Development Application **ACCESS REPORT**

Reference Number: 22250

Site Address: 27 Waine St, Freshwater

Executive Summary and Design Compliance Statement

[Image description: Plan of basement above shows the provision of Accessible parking spaces]

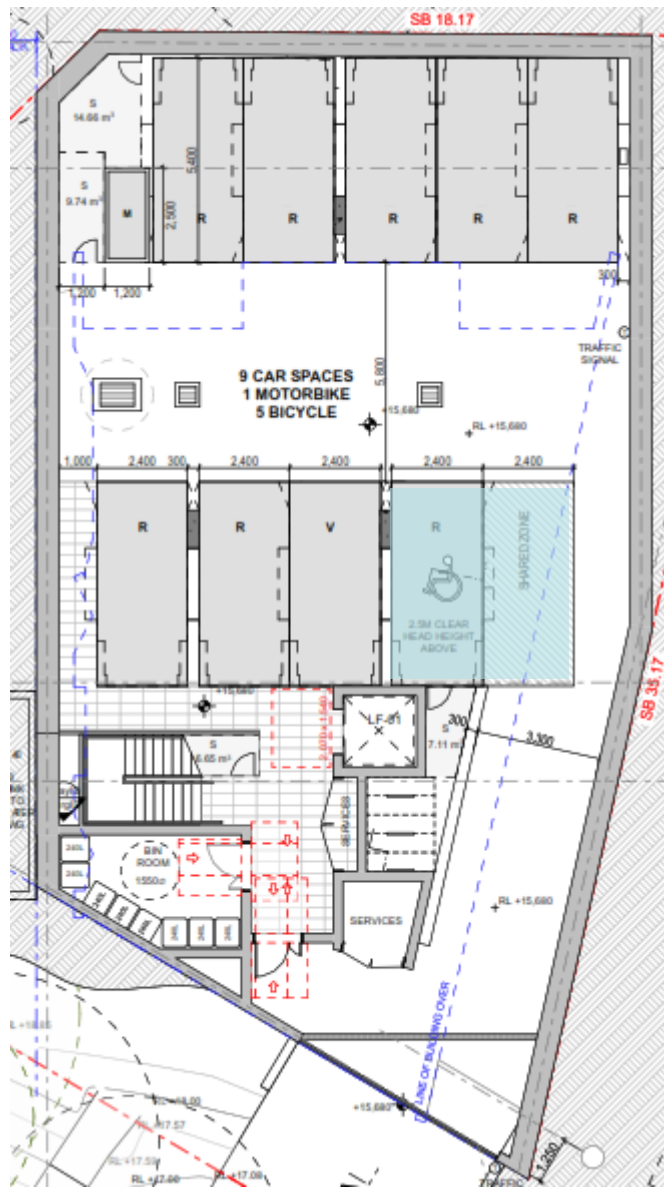
Capable of compliance (Subject to performance solution for accessible car parking space design at CC stage)

Subject to performance solution at CC stage

Northern Beaches Council requires provision of 10% Adaptable units in the development. Development has total number of 4 units. $10\% \text{ of } 4 = 0.4 = 1$ required Adaptable unit. Therefore, 1 accessible carparking spaces are required for the residential component of the development.

1 Accessible car parking spaces has been provided in development which is required to be allocated to the Adaptable unit.
